UNITED STATES PATENT AND TRADEMARK OFFICE

Application No.	Applicant(s)	
_	10/616,711	ZHANG, SHE SHUN	
Office Action Summary	Examiner	Art Unit	
	Terence Boes	3682	
The MAILING DATE of this communicatio Period for Reply	n appears on the cover sheet v	vith the correspondence address	
A SHORTENED STATUTORY PERIOD FOR R WHICHEVER IS LONGER, FROM THE MAILIN - Extensions of time may be available under the provisions of 37 C after SIX (6) MONTHS from the mailing date of this communication. - If NO period for reply is specified above, the maximum statutory Failure to reply within the set or extended period for reply will, by Any reply received by the Office later than three months after the earned patent term adjustment. See 37 CFR 1.704(b).	NG DATE OF THIS COMMUN FR 1.136(a). In no event, however, may a on. period will apply and will expire SIX (6) MC statute, cause the application to become A	ICATION. I reply be timely filed INTHS from the mailing date of this communication ABANDONED (35 U.S.C. § 133).

DETAILED ACTION

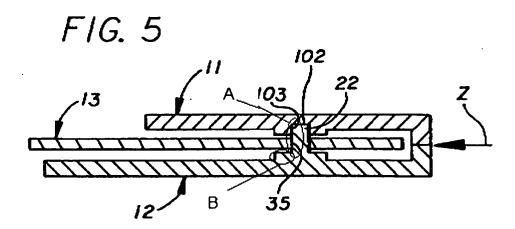
- A housing (10) having a bore (103)
- Closed inner end (See Fig. 5 @ 103)
- Bearing (22) having a smooth end, first and second walls forming first and second shoulders (see fig 5 below, A and B respectively)
- Slot (see Fig. 5 between housing members 11 and 12) extending part of the length of said housing (10)
- Said second wall being located within said slot (see fig 5 below)
- Operator arm (13) disposed therein
- First wall (see fig. 5 below, A) with smaller diameter than second wall (see fig. 5 below, B).
- First shoulder (see fig 5 below, A) rests against a first wall (11) of slot (see
 Fig. 5).

Second shoulder (see fig 5 below, B) rests against a second wall (12) of slot (see fig 5 below, B)

a. The examiner notes that Winner discloses said smooth end having first and second walls forming first and second shoulders (see included fig 5, A and B).
